Westinghouse
Electric Corporation

NTD-NRC-96-4630
DCP/NRC0453
Docket No: STN-52-003

SUBJECT: WESTINGHOUSE RESPONSES TO NRC REQUESTS FOR ADDITIONAL
INFORMATION ON THE AP600

NRC REQUEST FOR ADDITIONAL INFORMATION

Figure 440.482-8

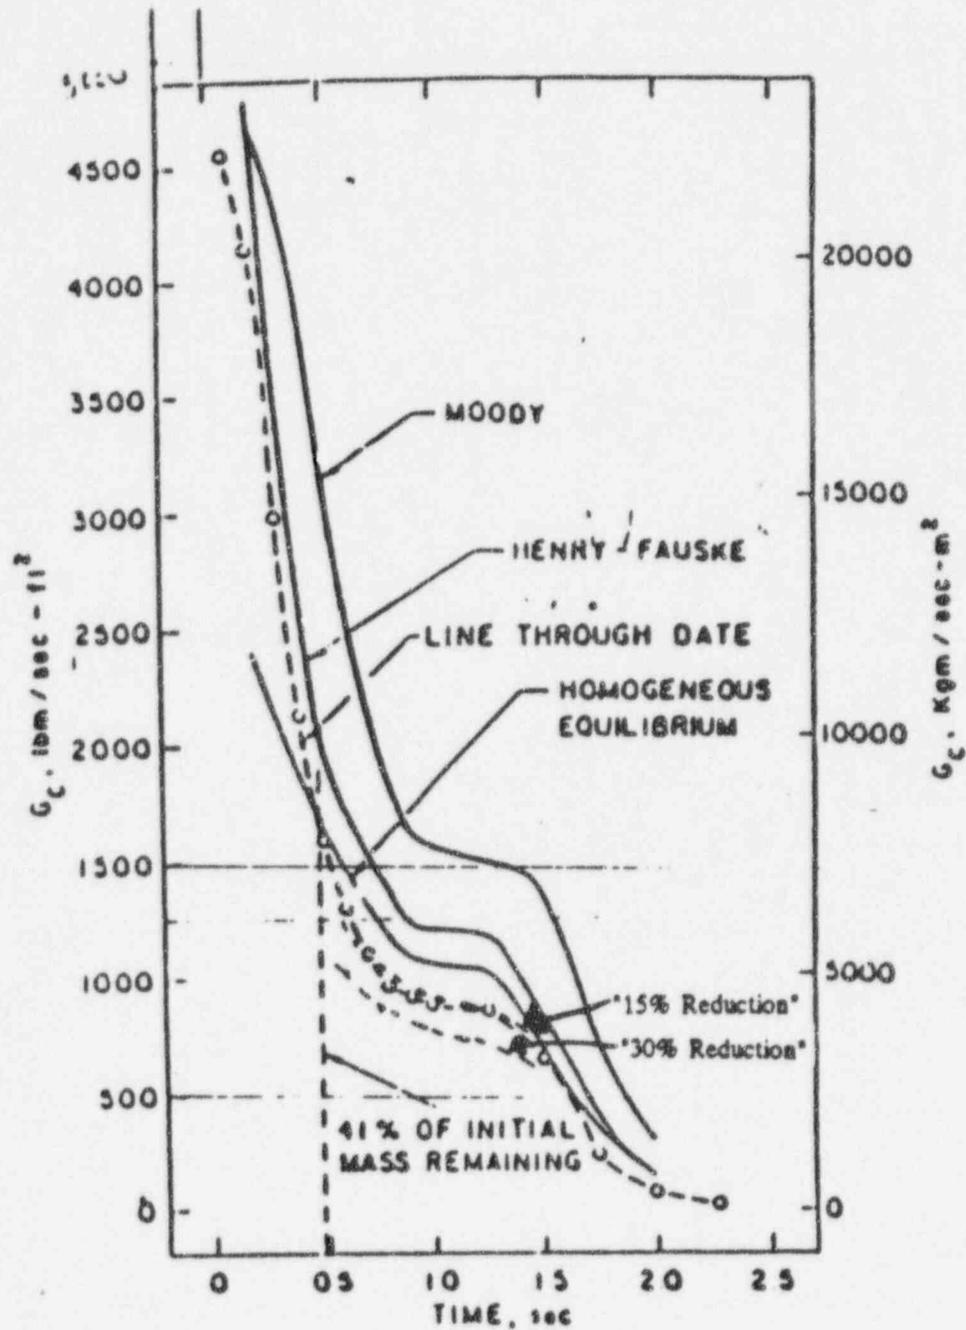
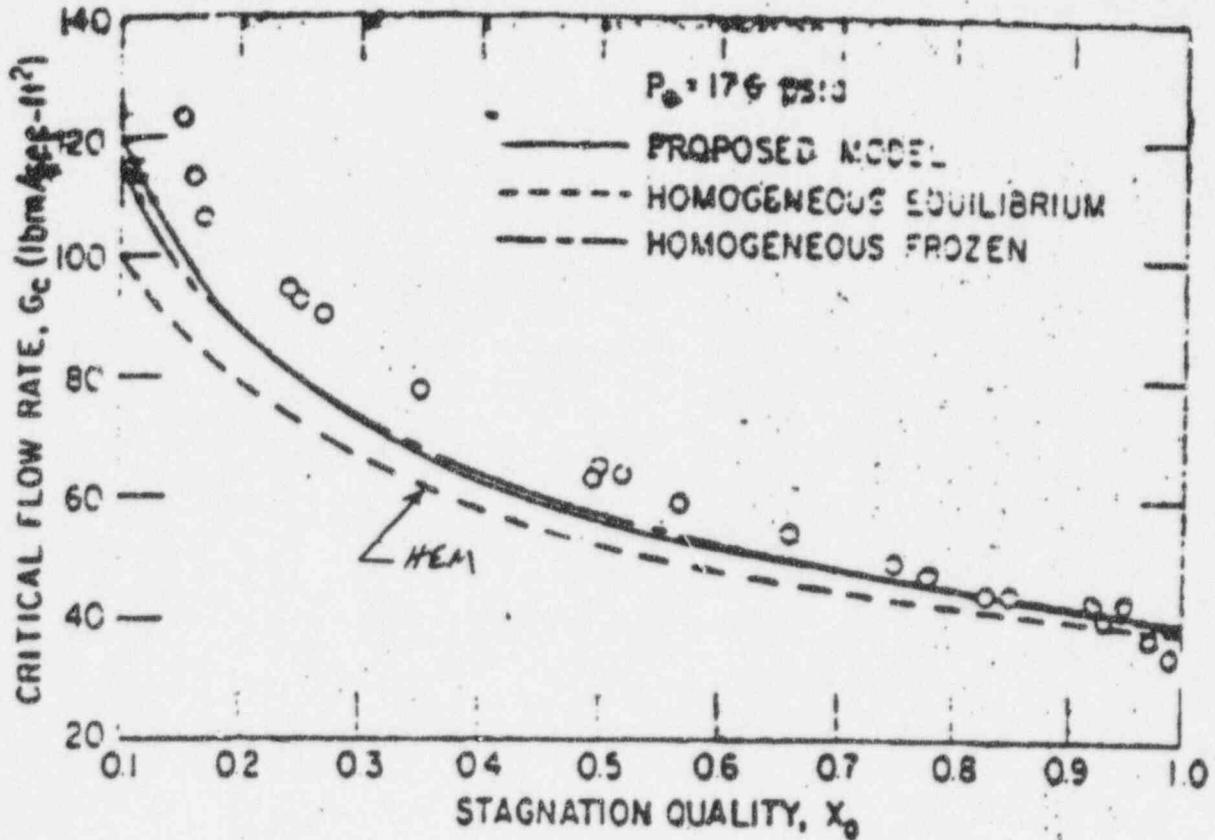
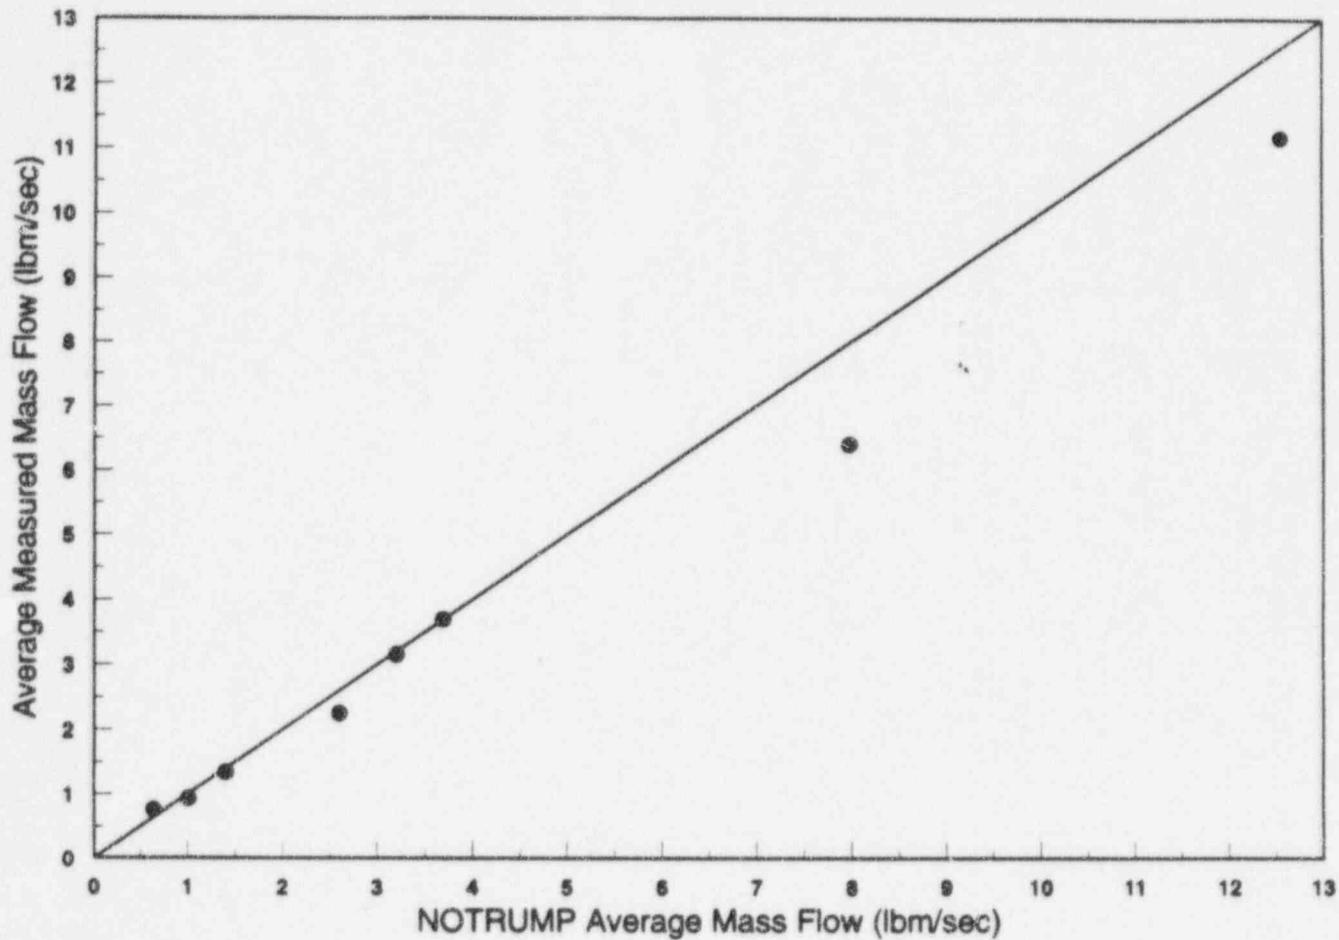
440.482 Please provide benchmark of the new critical flow model versus critical flow tests to justify and verify the coding changes. Also, please describe the model for unchoked conditions and explain how the model treats the transition from choked to unchoked conditions. Consider selected Marviken critical flow data for verifying the NOTRUMP code's ability to simulate subcooled, saturated two-phase, and single phase steam discharge.

The validity of these two models was assessed in the response to RAI 952.95 which documented the ADS 4 valve area sensitivity study. RAI 952.95 examined the uncertainty in the critical flow from these two models to assess the margin in the ADS stage 4 valves. The uncertainty was typically found to be approximately 15% for the models over a range of pressures and inlet enthalpies for different tests. Comparisons were taken from the literature as well as the original papers. Figures 440.482-1 to 440.482-6 were taken from Reference 440.482-2 for the Henry/Fauske model for the subcooled and low quality portion of the flow. The references given in the figure titles refer to the references given in Reference 440.482-2. The figures show the agreement of the Henry/Fauske correlation for difference sets of data and different fluids. Superimposed on these figures are the model predictions multiplied by 0.85 and/or 0.7 to indicate a 15% to 30% uncertainty of the model relative to the data. As the figures indicate, the Henry/Fauske model agrees very well with the data, usually within 15%.

Similar plots for the HEM model are given in Figures 440.482-7 to 440.482-9 from references 440.482-2 and 440.482-3. As the figures indicate, the HEM model agrees within 15% for the data shown.

The data comparisons given in Figures 440.482-1 to 440.482-7 do not cover the full pressure range for the AP600 small-break LOCA, but rather cover the low pressure portion of the transient. The NOTRUMP SPES and OSU comparisons provided in the preliminary validation reports provide additional validation over the higher pressure range from 2250 psia down to 140 psia which overlaps with the data comparisons given in Figures 440.482-1 to 440.482-9. The method used for the SPES and OSU comparisons to the NOTRUMP predictions with the Henry/Fauske - HEM critical flow model was to use the integrated flow measurements from the beginning of the test, until the ADS stage 1 valve opened. The integrated flow (lbms) was divided by the time to reach ADS stage 1 to obtain an average mass flowrate out the break. The earlier of either the data or the prediction was used for the ADS stage 1 opening time for a given test. By using the integrated break flow data over this time period, the only flow path out of the system was through the break. Also, by selecting the time period before ADS stage 1, the additional complications of timing differences between the code and the data and a more complex mass distribution within the primary system are avoided. Figure 440.482-10 shows the comparison of the average break flow predicted by the NOTRUMP code and the measured average flow rate. Figure 440.482-11 shows the ratio of the measured flowrate to the predicted flowrate for the different tests. Both figures indicate that the combined Henry/Fauske - HEM model represents the critical flow with the similar uncertainties as the comparisons with the original data. The poorest comparison was the tests SB10, the double-ended cold line balance line break. If the measured-to-predicted
